2 Type of change

Product Change Notification					FAU improvement		
owner	creation date	release date	released by	change order no	rev	page	D10-013-730
dislercy	2017-02-09	2017-06-02	nowakfr	2010875	A	1 of 2

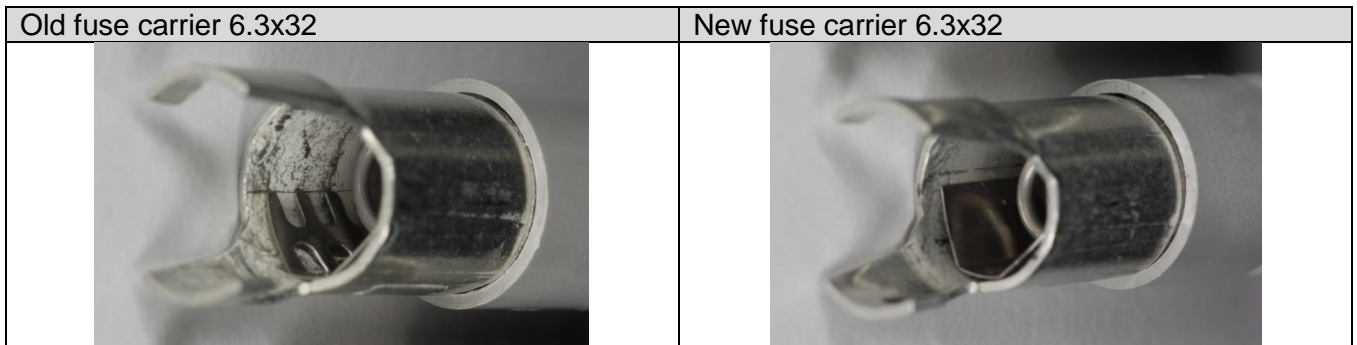
- Change of material
- Modified label
- Change of marking
- Improved voltage rating
- Improved electrical contact
